VA786-16-R-0160

ATTACHMENT B - TECHNICAL DRAWINGS

Project Title	WASHINGTON CROSSING NATIONAL CEMETERY
---------------	--

Drawing Title	Project Title	Project Number
Approved: Project Director	Location BUCKS COUNTY, PENNSYLVANIA	Building Number -
Date	Checked	Drawn
		926-M&R16-08-01

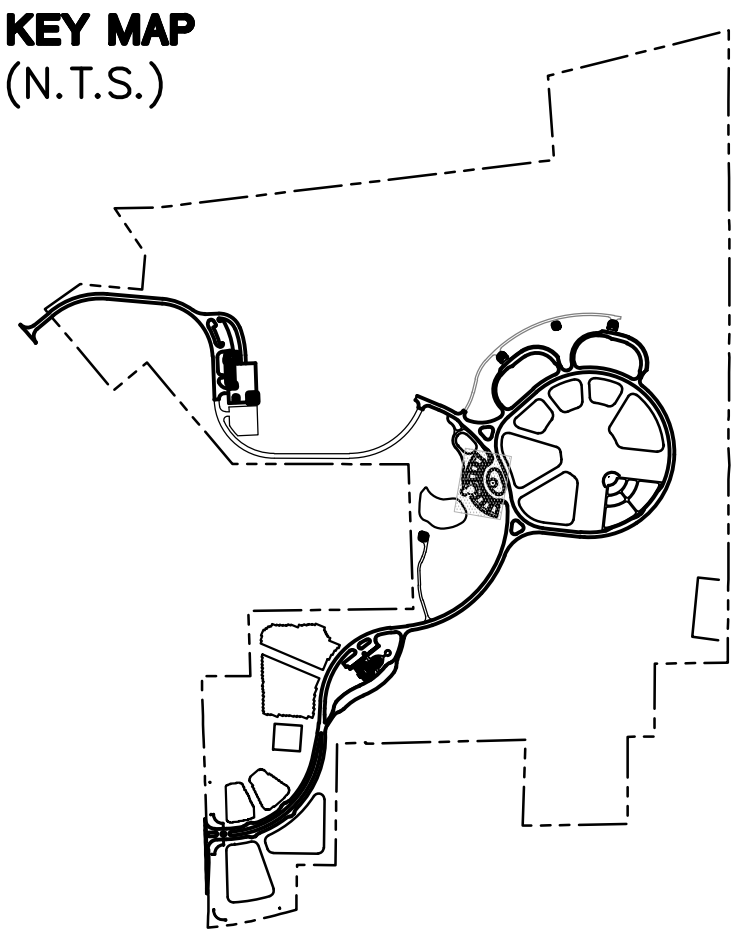
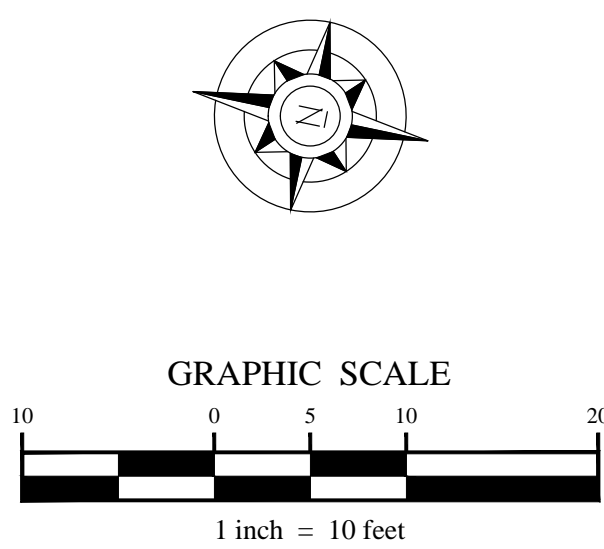
Replace all concrete sidewalk slab in these two circular areas. See specification 010002-1.2-B-1.

1. Replace 10 sections of concrete sidewalk. Locations to be coordinated with COR, typical all work this sheet. See specification 010002-1.2-B-2. Note this work is in addition to the shown circular areas of concrete replacement highlighted on this plan.

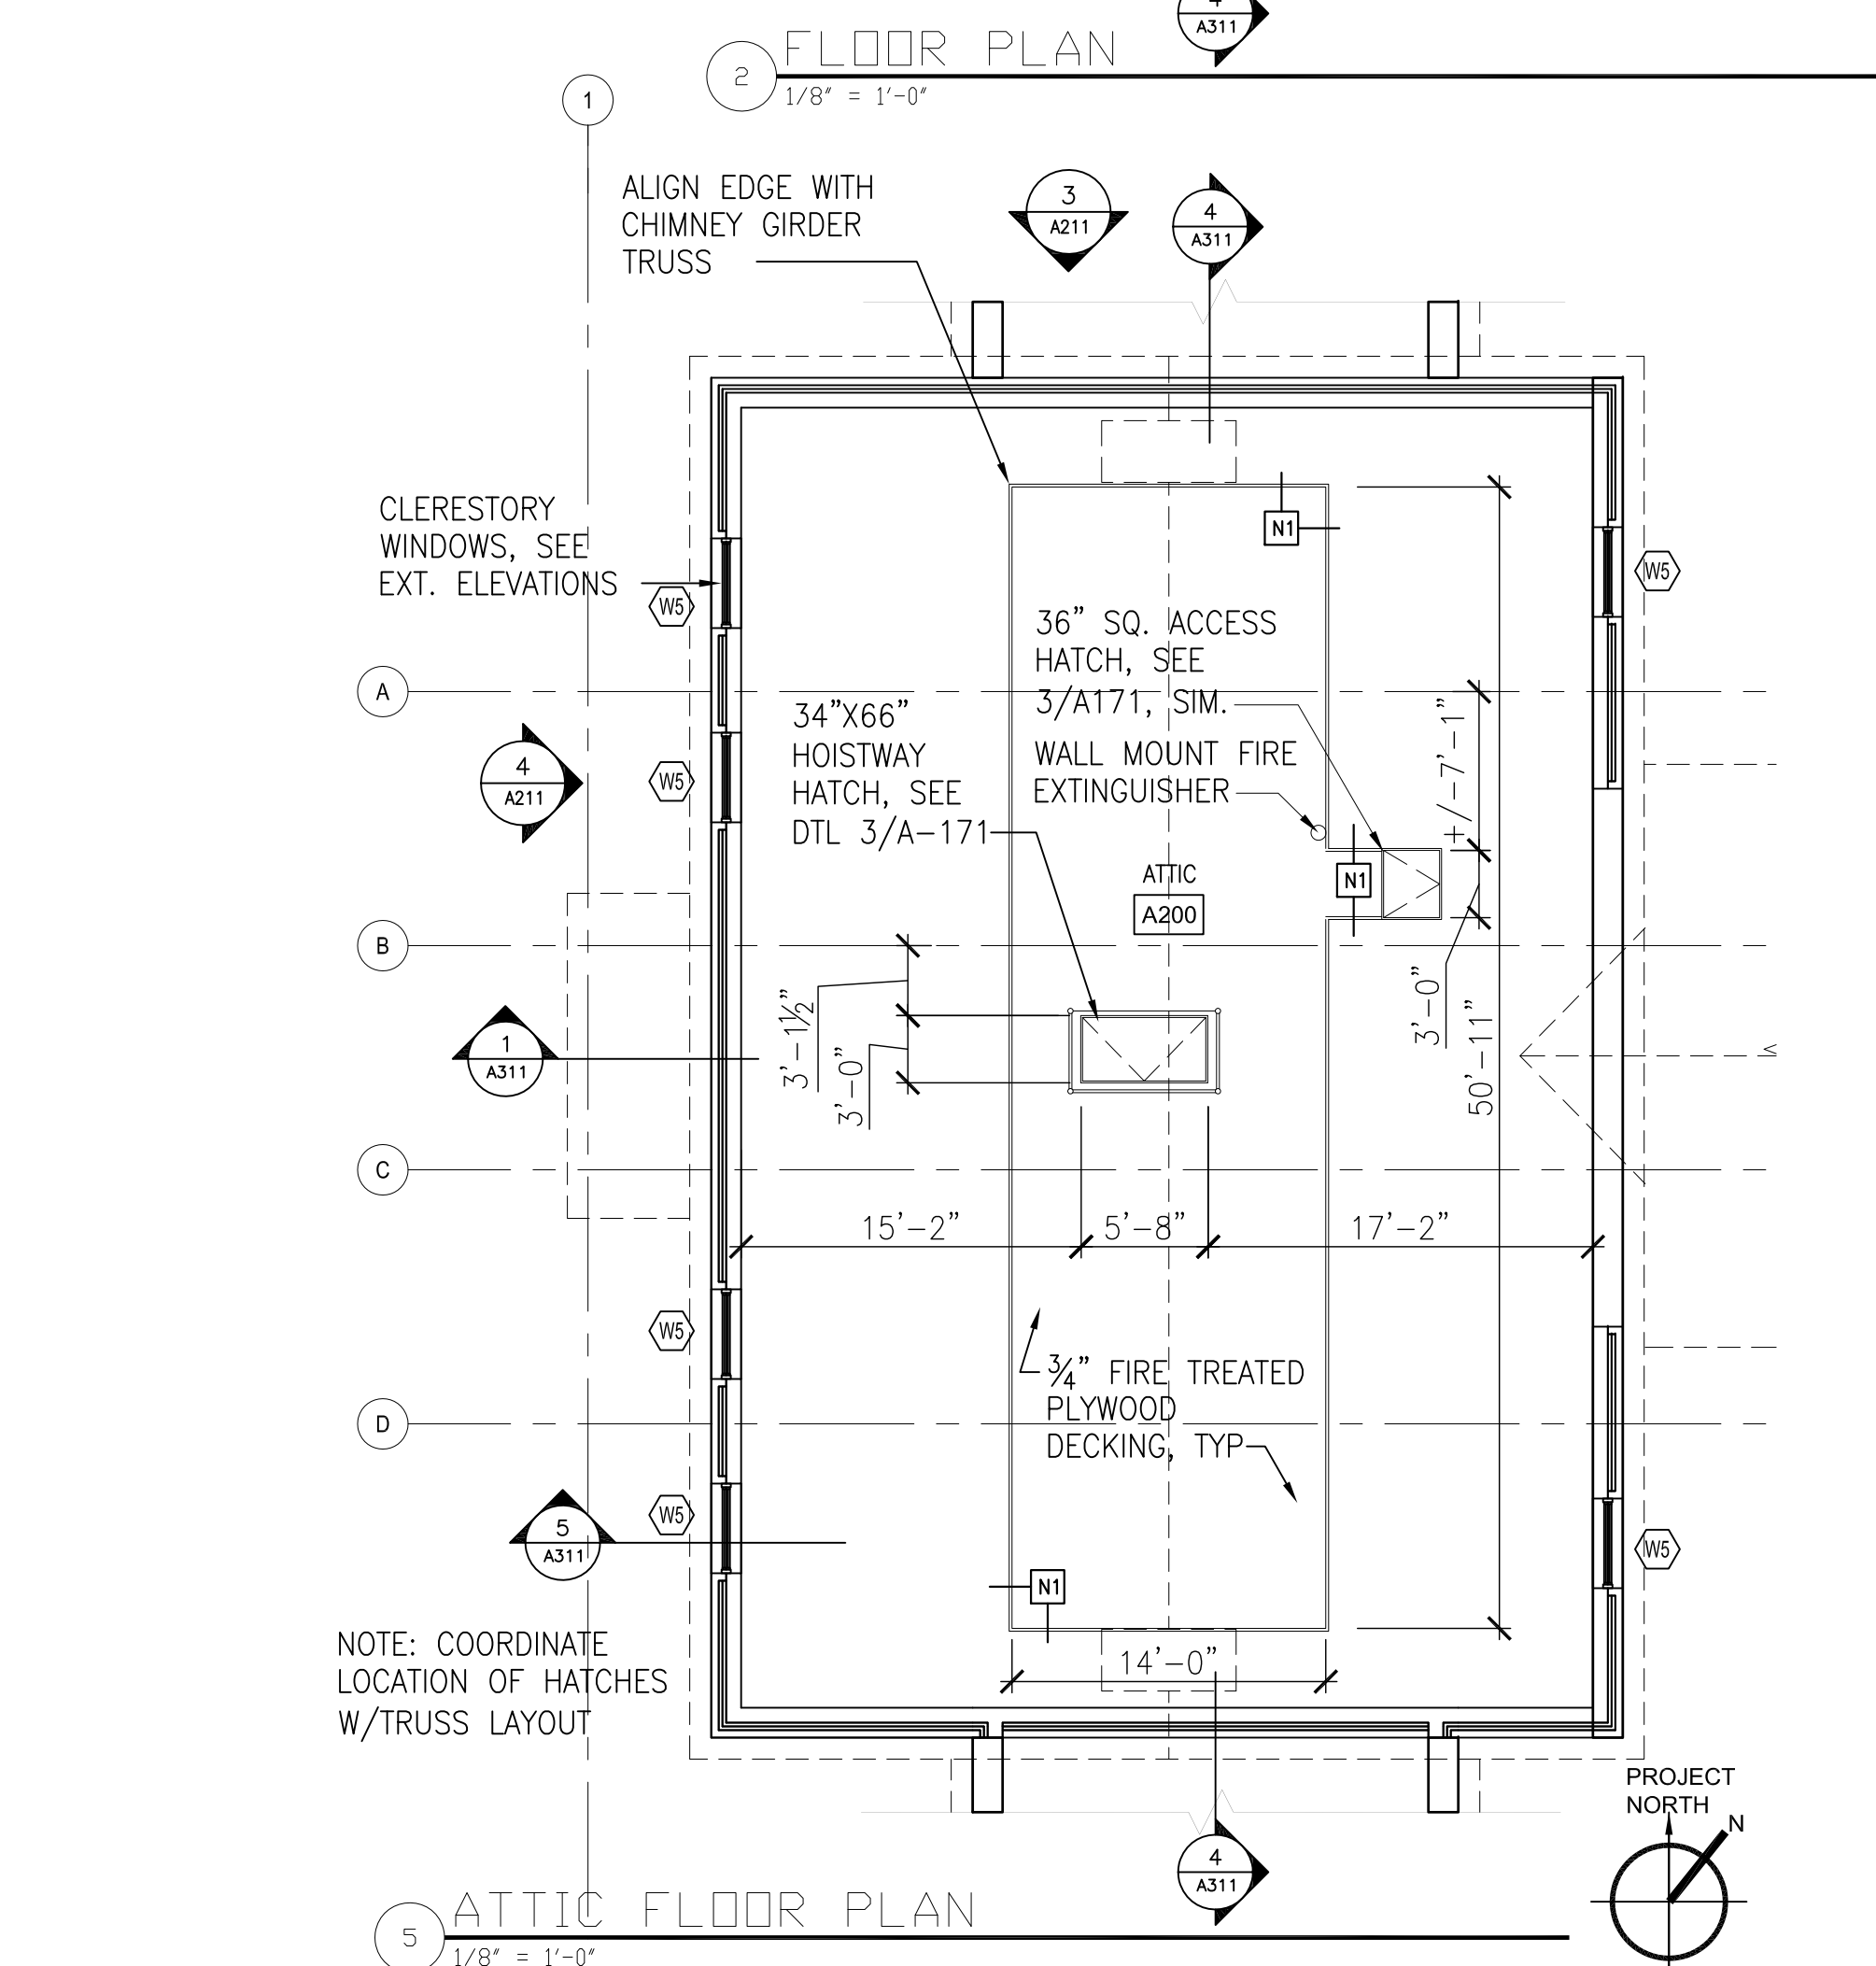
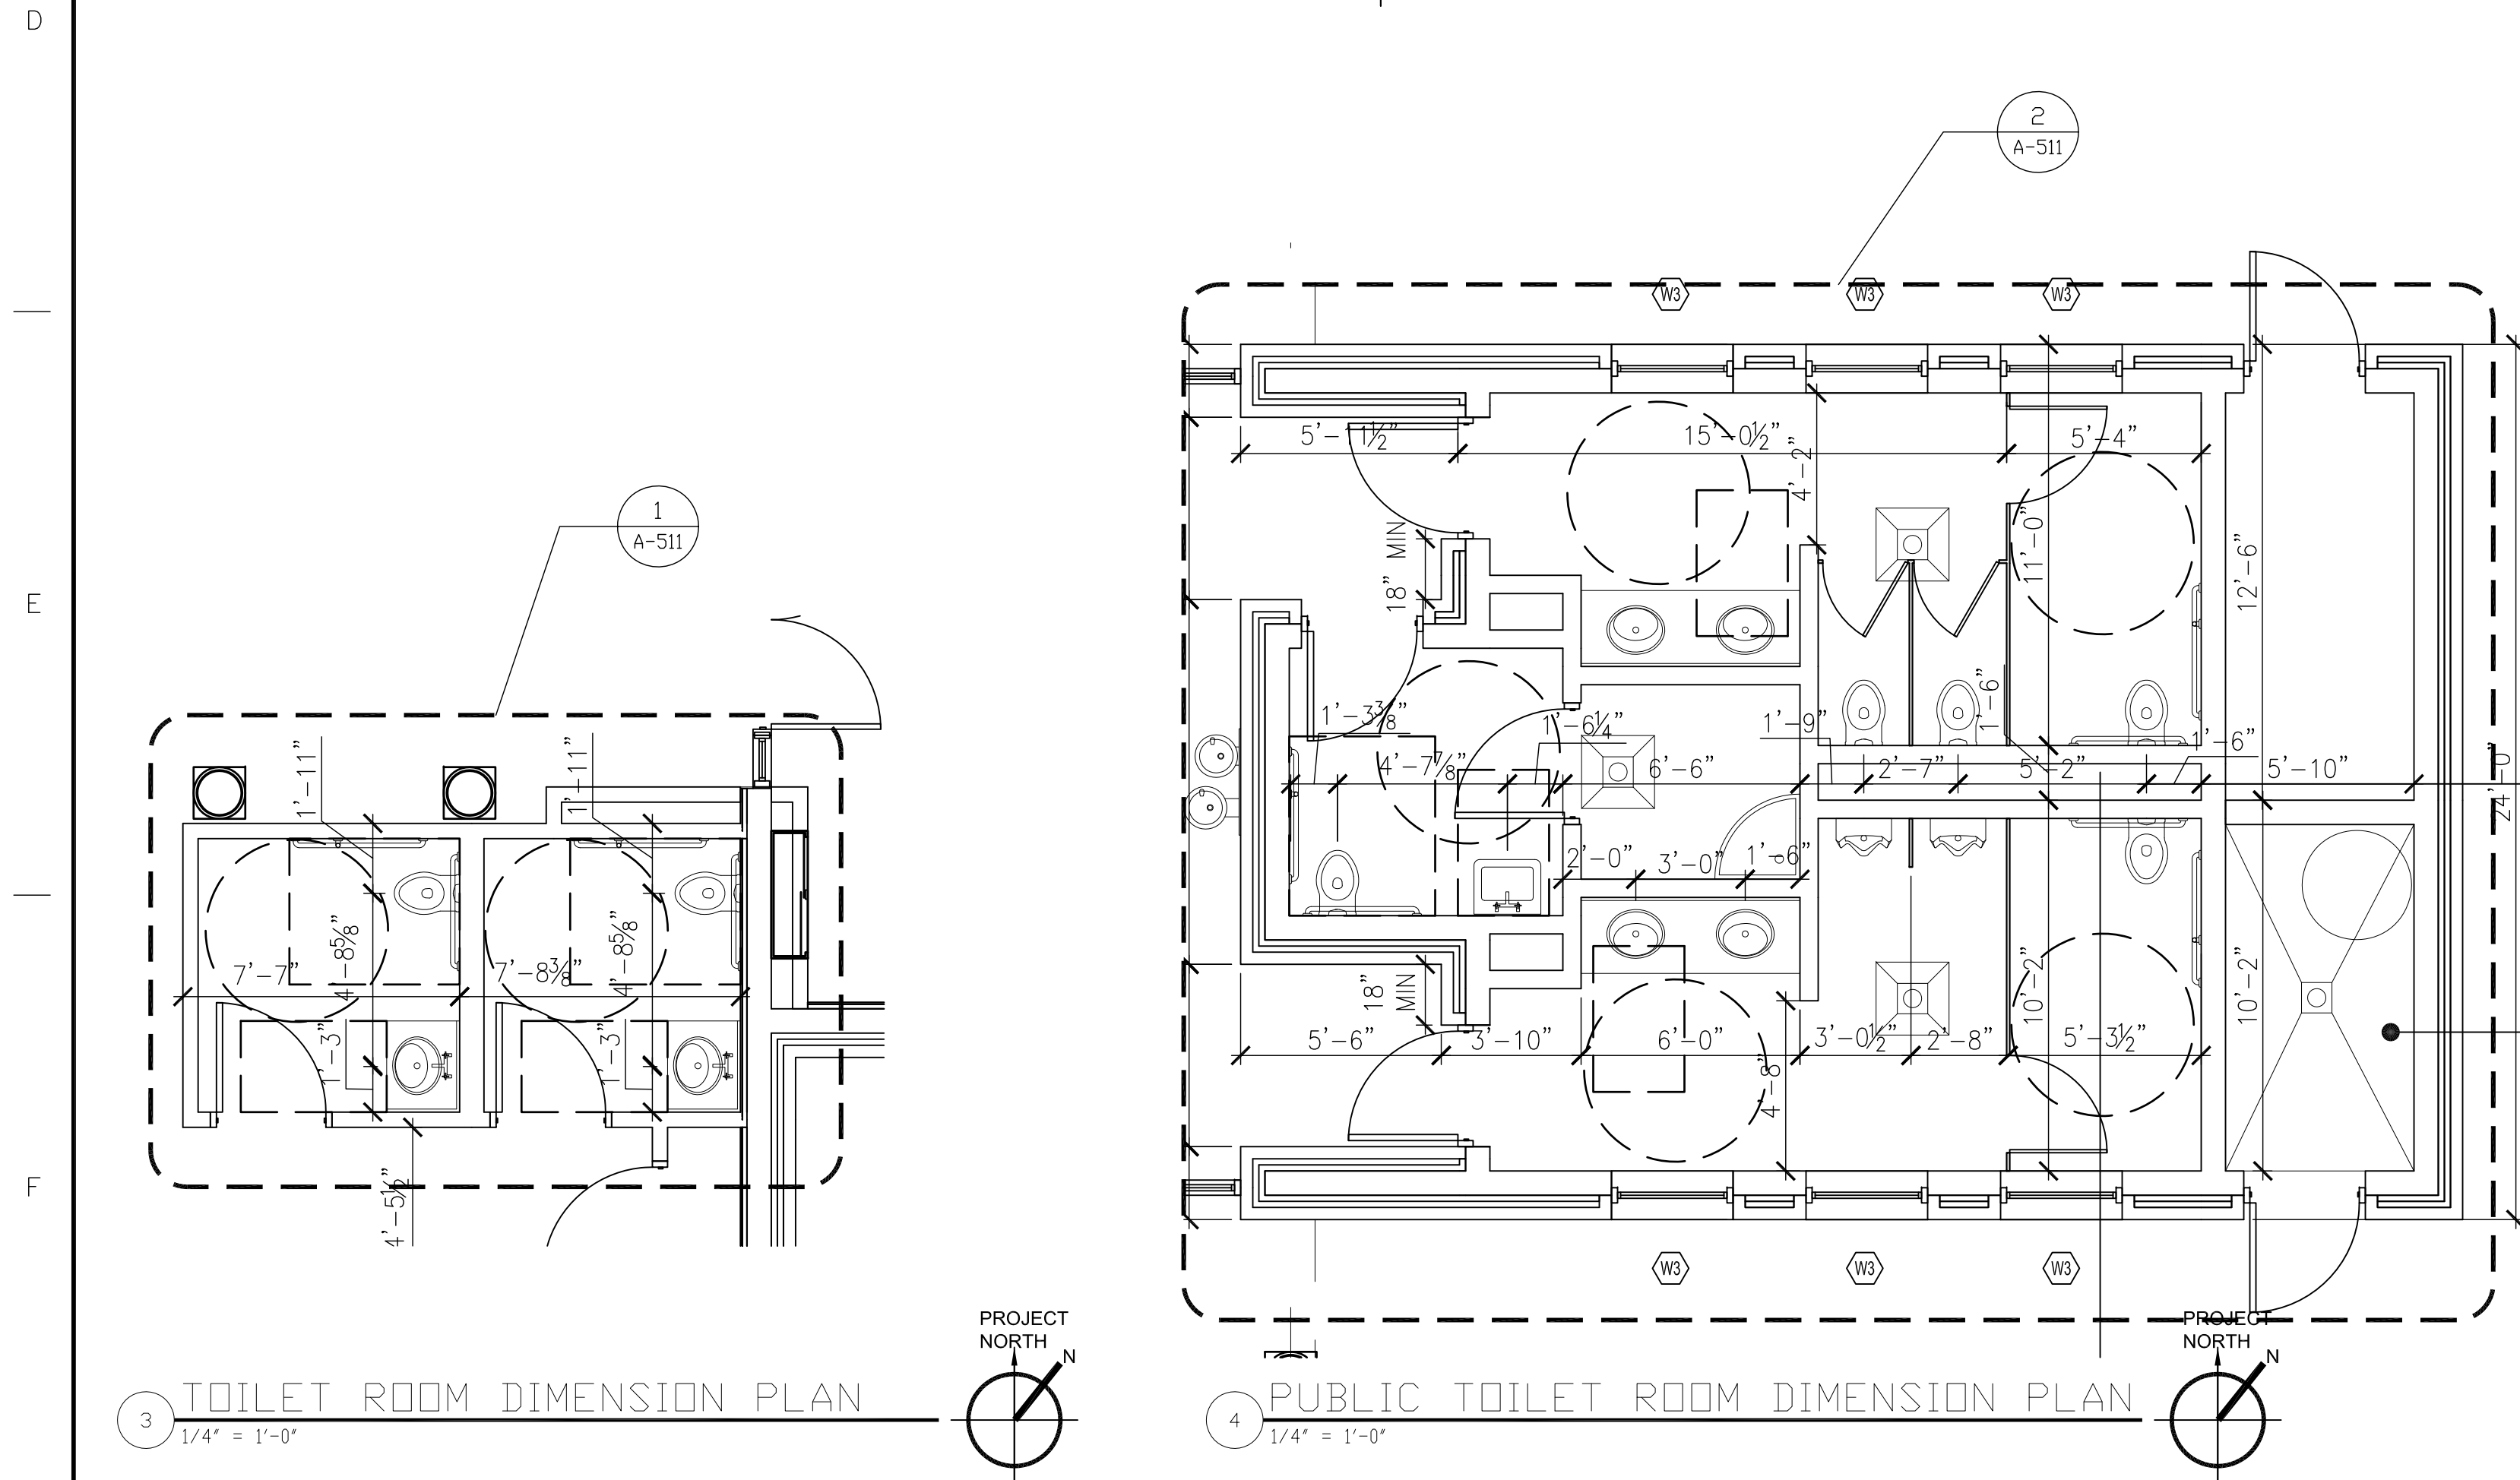
Circled doors require frost heave solution and slab work. See specification 010002-1.2-B-7 for more information.

General work: Demolish all existing flooring, prep slab, and install new vinyl sheet flooring on entire building's floor shown in this detail 2 Floor Plan. See specification 010002-1.2-B-9 for more information.
